Project Memorandum

To: KGHM Ajax Mining Inc. **Doc. No.:** BGC-006
Attention: Nettie Ore **cc:**
From: Cassandra Koenig **Date:** May 30, 2016
Subject: Ajax Project EA/EIS –
Responses to Information Requests COK-SLR568 and ECCC-001
Project No.: 1125011

Figure 02. Surficial materials: Hydraulic conductivity test locations and distribution within model layer 1.

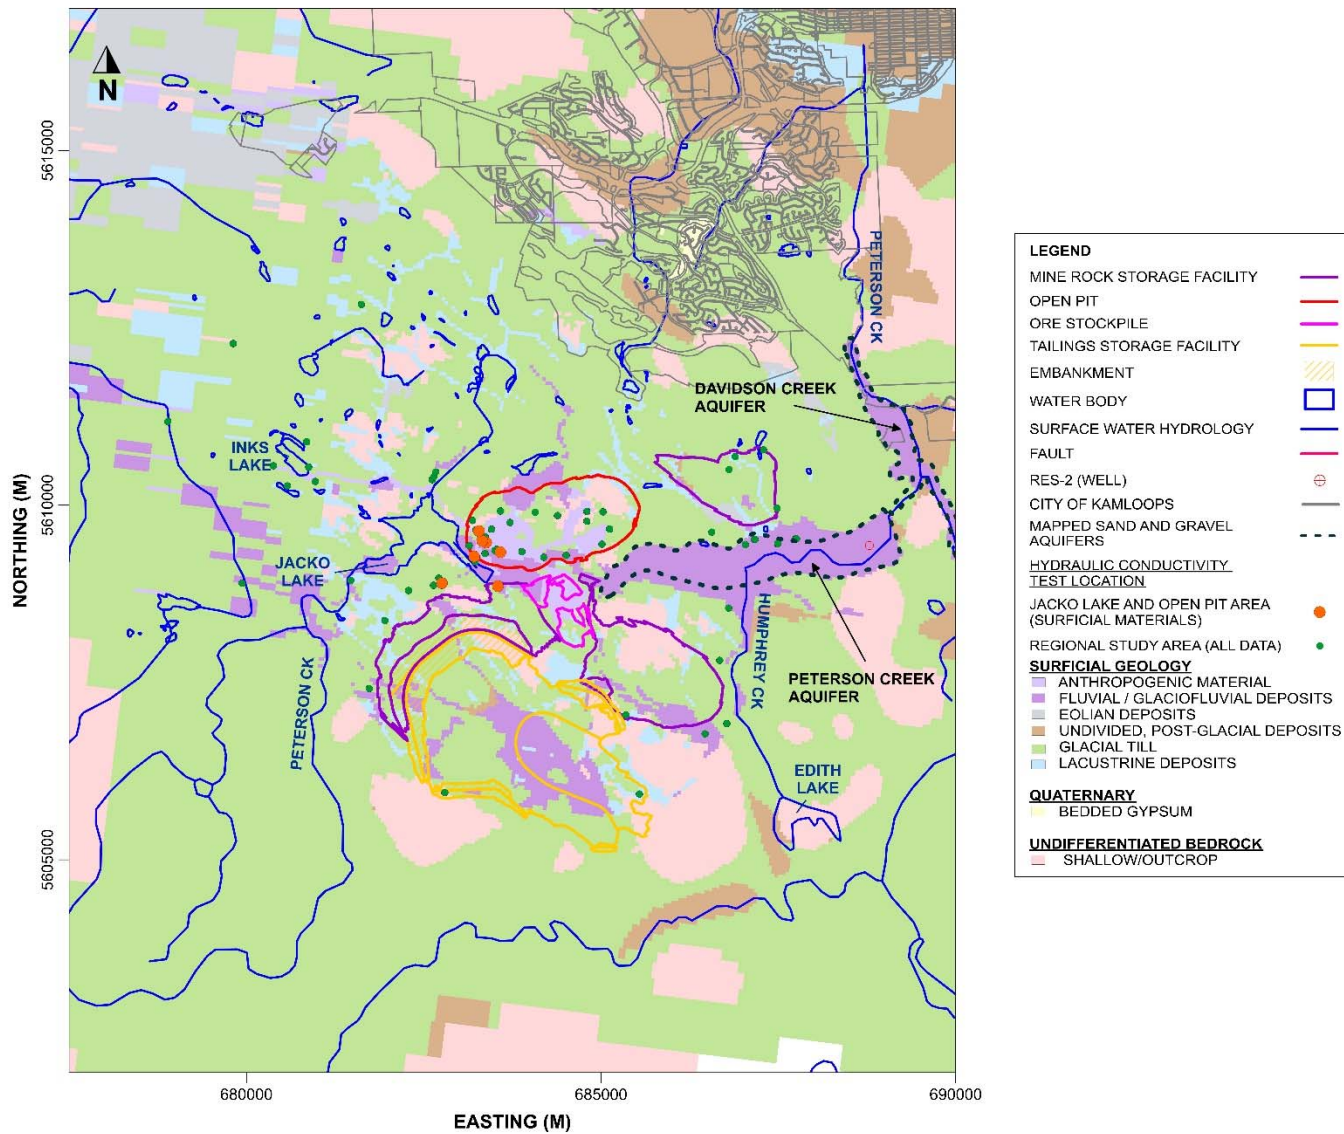
Memo number SLR017 specifically points to Appendix K (K-1, Application/EIS Appendix 6.6-A), containing a regional interpretation of the extent of glaciofluvial deposits and suggests that the mapped glaciofluvial deposits may not have been conservatively represented within the model as a continuous, high permeability (i.e., "...as high as 10^{-5} m/s") hydrostratigraphic unit. It should be noted that memo number SLR017 fails to note the more discontinuous nature of these deposits when mapped at a finer scale as also presented on the following page of Appendix K (K-2, Application/EIS Appendix 6.6-A).

However, to clarify, within the numerical groundwater flow model these glaciofluvial deposits were represented as a continuous (Figure 02 below; Figure 08, Application/EIS Appendix 6.6-D), higher hydraulic conductivity (i.e., 1.4×10^{-5} m/s; Table 02 below; Table 01, Application/EIS Appendix 6.6-D) hydrostratigraphic unit as constrained by available borehole data. Furthermore, all surficial deposits overlying the bedrock were assumed to be uniform with depth (Section 5.2.1, Application/EIS Appendix 6.6-D). As a result, the thickness of coarse materials within the mapped extent of these glaciofluvial/fluvial deposits between Jacko Lake and the open pit was likely over-estimated as thick sequences of dense silty to clayey glacial till have generally been found to be interspersed (Appendix A, Application/EIS Appendix 6.6-A). In this respect, the numerical groundwater flow evaluation of seepage from Jacko Lake to the proposed open pit via these sediments is considered to be reasonable and conservative.

Figure 04. Hydraulic conductivity (K) of faults versus depth.

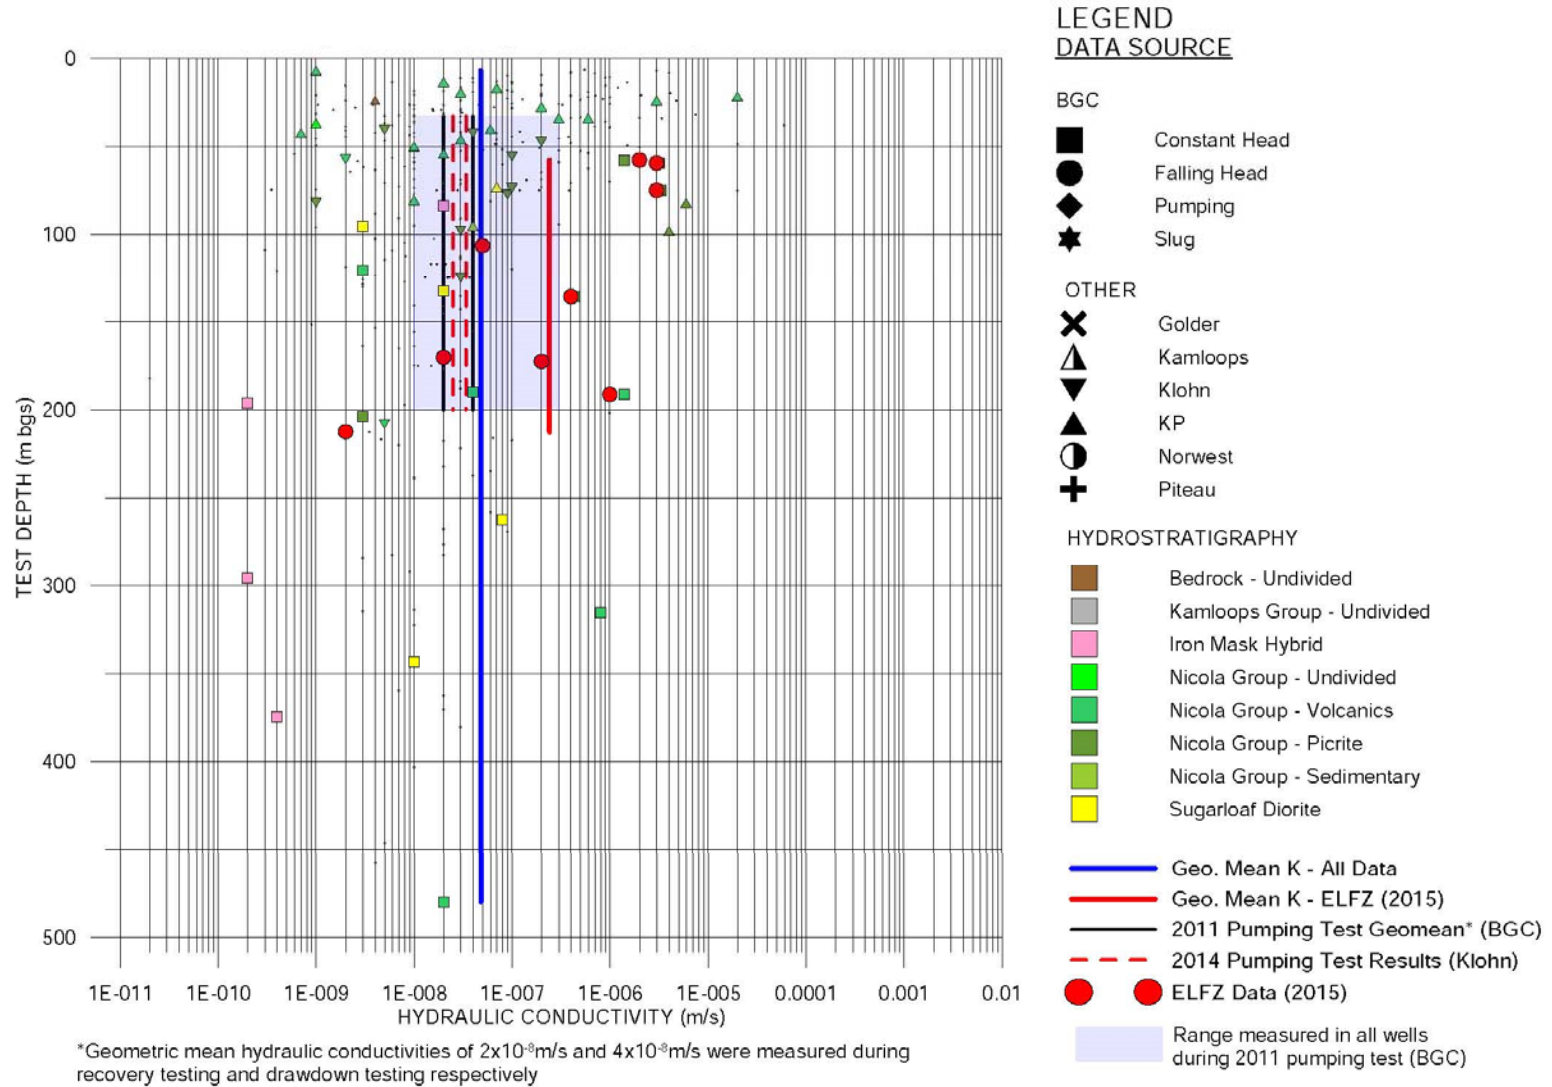
- *There are a number of vertical and sub-vertical faults within the proposed project area and weak rock formations within the western sector of the Ajax pit.*
- *Assess the potential for groundwater seepage from Jacko Lake to the proposed Ajax pit via sub-vertical fault structures present in the western sector of the pit. What hydraulic conductivities and volumes are probable?*
- *Should it be determined that groundwater seepage may occur, provide mitigation measures to reduce potential impacts to groundwater and surface water quality.*

Within the bedrock, the geometric mean hydraulic conductivity (i.e., 2×10^{-8} m/s; Table 01) from point-scale tests (i.e., slug and packer tests) was similar to ranges estimated from pumping test results (i.e., 1.7×10^{-8} m/s to 4.1×10^{-8} m/s; BGC, 2011). The close agreement of the geometric mean hydraulic conductivity from point-scale test results with the larger-scale, best-fit estimates of hydraulic conductivity obtained from the pumping test interpretation provide good confidence in the characterization of the bulk permeability of the fractured rock mass in this area of the Project. Furthermore, characterization of the hydraulic conductivity of faulted and sheared rock along with contacts between rock units was a specific focus of the investigations within the pit area. Compilation of packer and slug testing results evaluating hydraulic conductivity of these features demonstrates that with the exception of test results in one borehole investigating the ELFZ, the distribution of hydraulic conductivity with depth for faults, shears and material contacts is consistent with the larger data population (Figure 04).
